CITY OF ALBUQUERQUE

January 3, 2022

**RE: New Mexico United Locker Room
5601 University Blvd. SE
Grading and Drainage Plan
Engineer's Stamp: None
Hydrology File: R15D002A**

Based upon the information provided in your submittal received 11/23/2021, the Grading and Drainage Plan can't be approved for Building Permit until the following comments are addressed:

A1 GRADING PLAN
SCALE: 1" = 50'

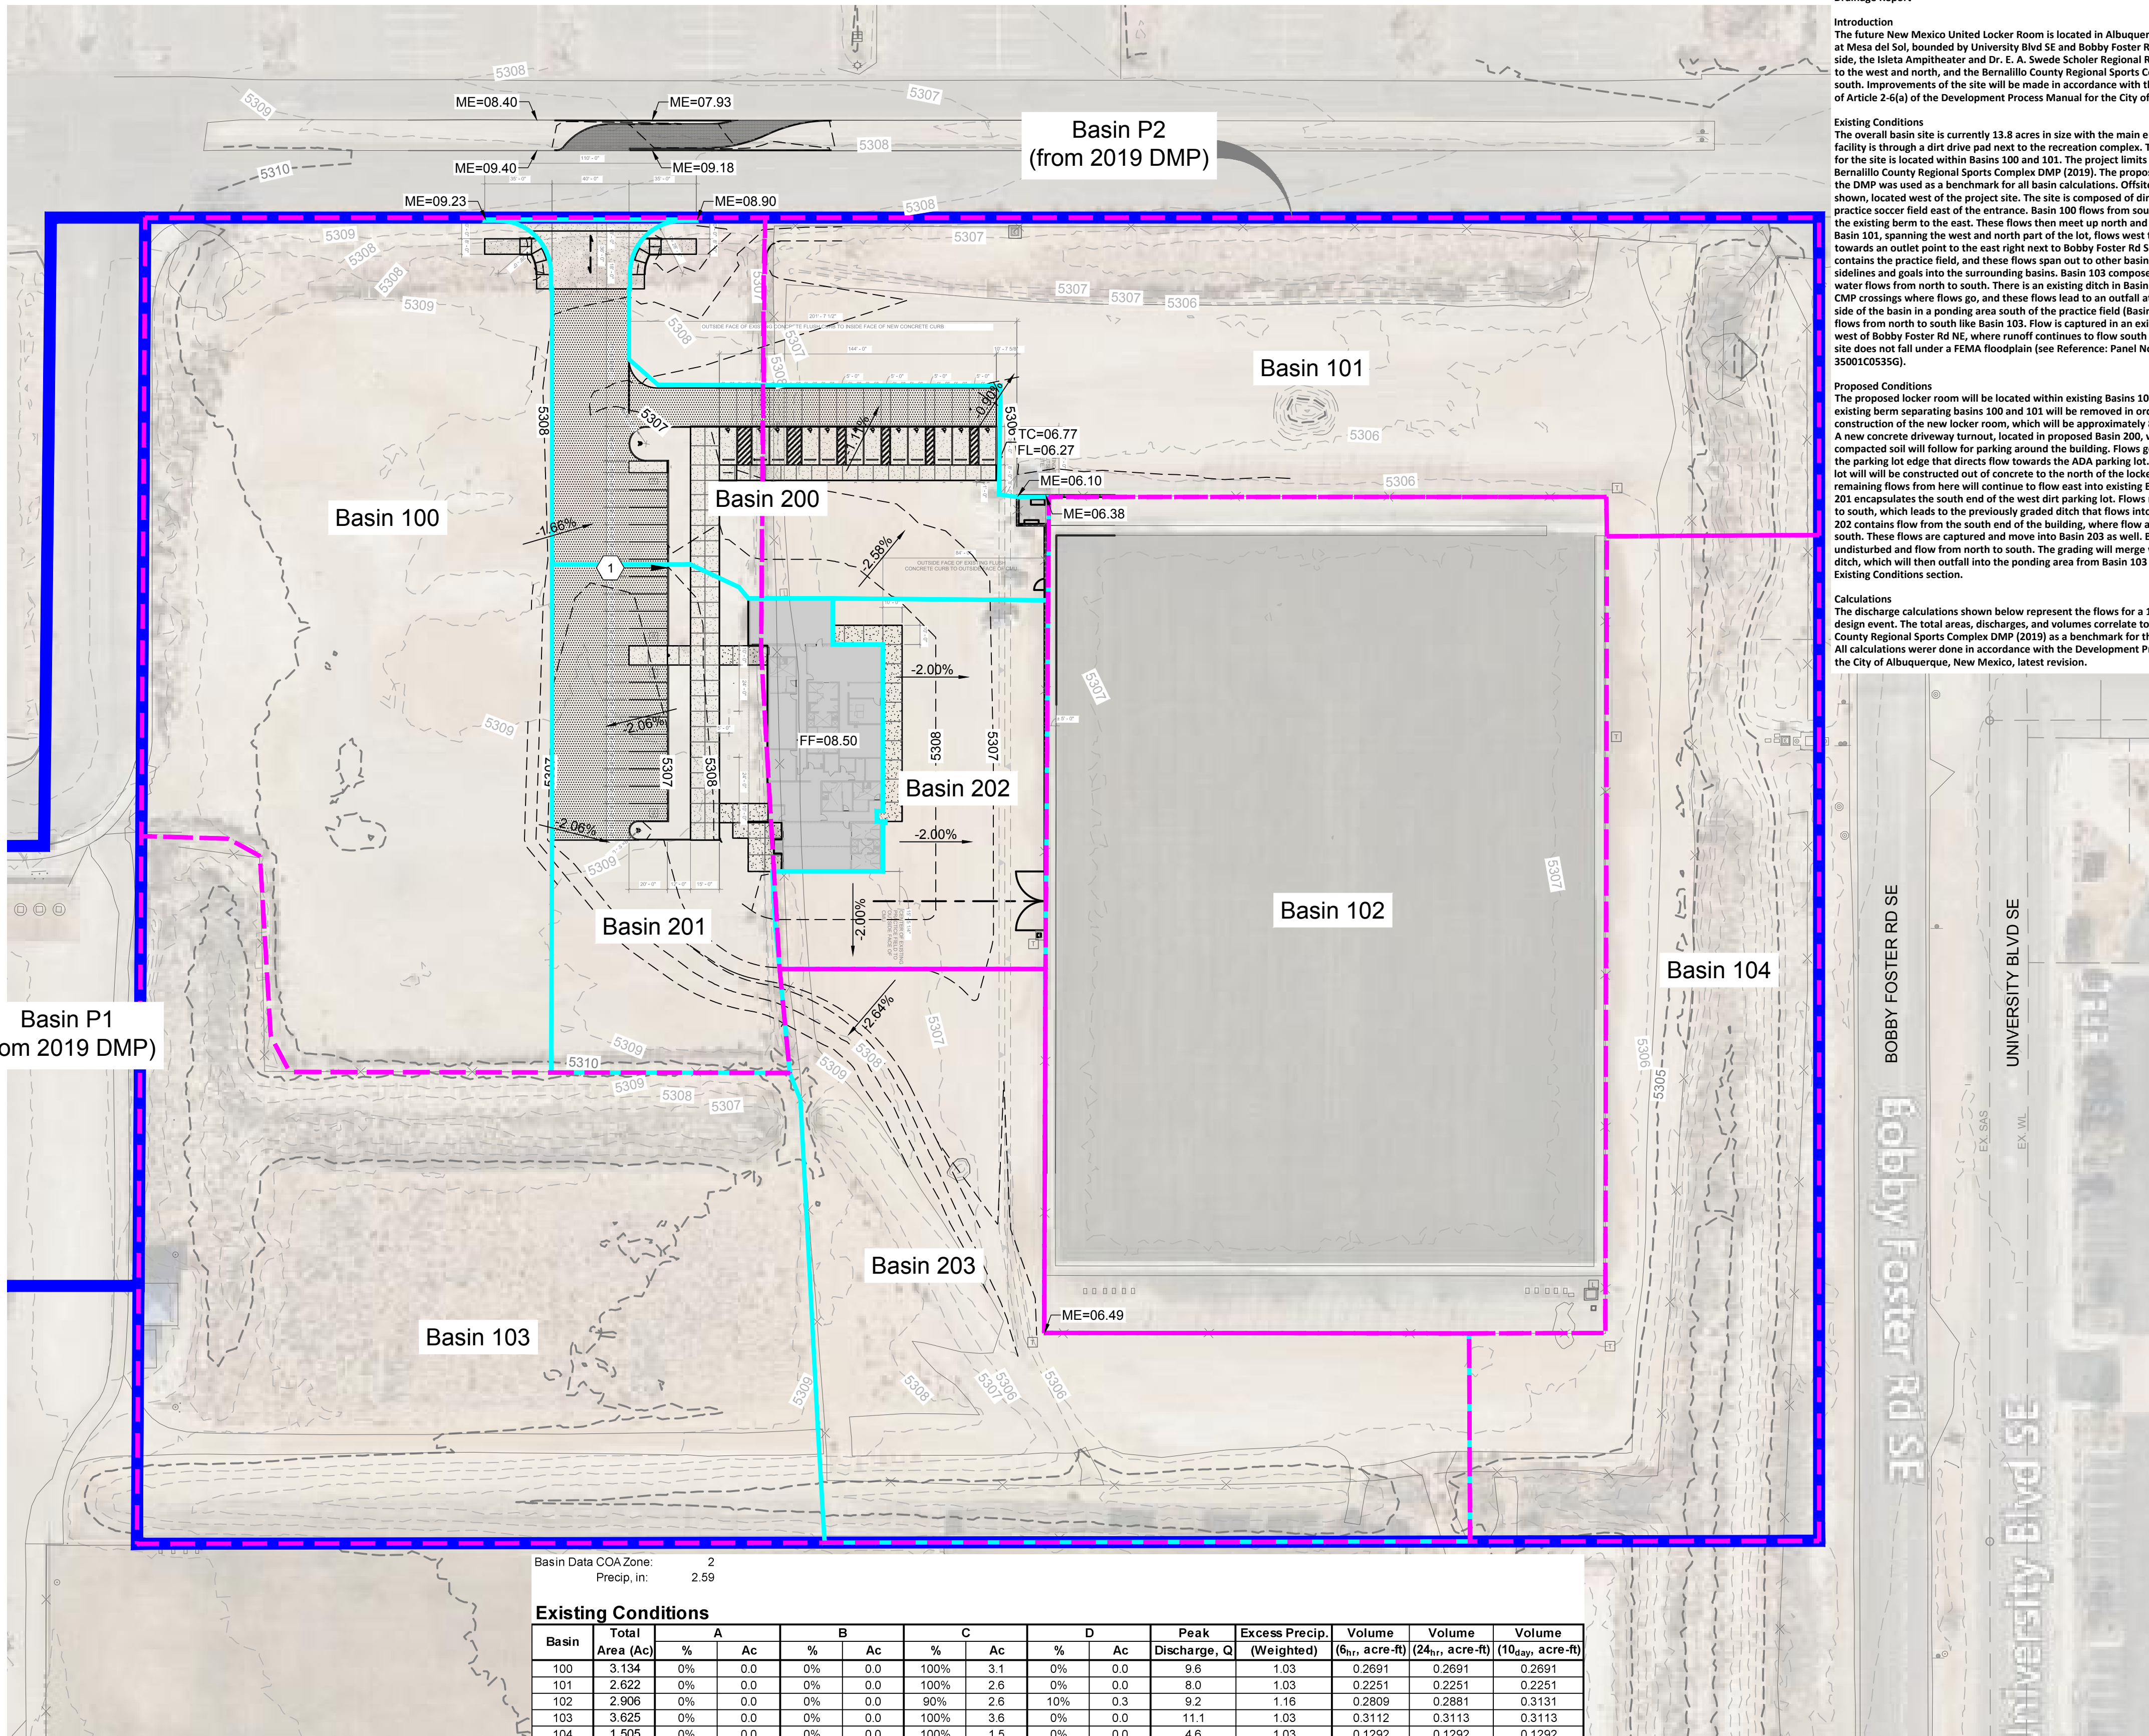
1. Please ensure the Grading and Drainage plan is stamped and signed by a NM Professional Engineer.
2. Please provide calculations for the required Storm Water Quality Volume (SWQV) and include on your plan where this volume will be ponded.

3. The narrative describes flows captured by an existing ditch, but does not provide for the capacity of the ditch or where these flows ultimately will be detained/retained. You must demonstrate downstream capacity of flows leaving the site or ponding capacity if retained/detained onsite.

4. You provide overall existing basin calculations, but then only provide calculations for new sub-basins in the proposed conditions. As the new design reconfigures the flow characteristics with the new basins crossing existing basin lines, you must provide total overall total existing and proposed calculations so we can compare existing versus proposed.

5. There has been a new submittal for a new storage building at the northeast corner of the field within Basin 101. Please coordinate with Scott McGee on his design and Grading and Drainage plan for this work so it can be incorporated with your overall site layout. I have also informed him to coordinate with you.
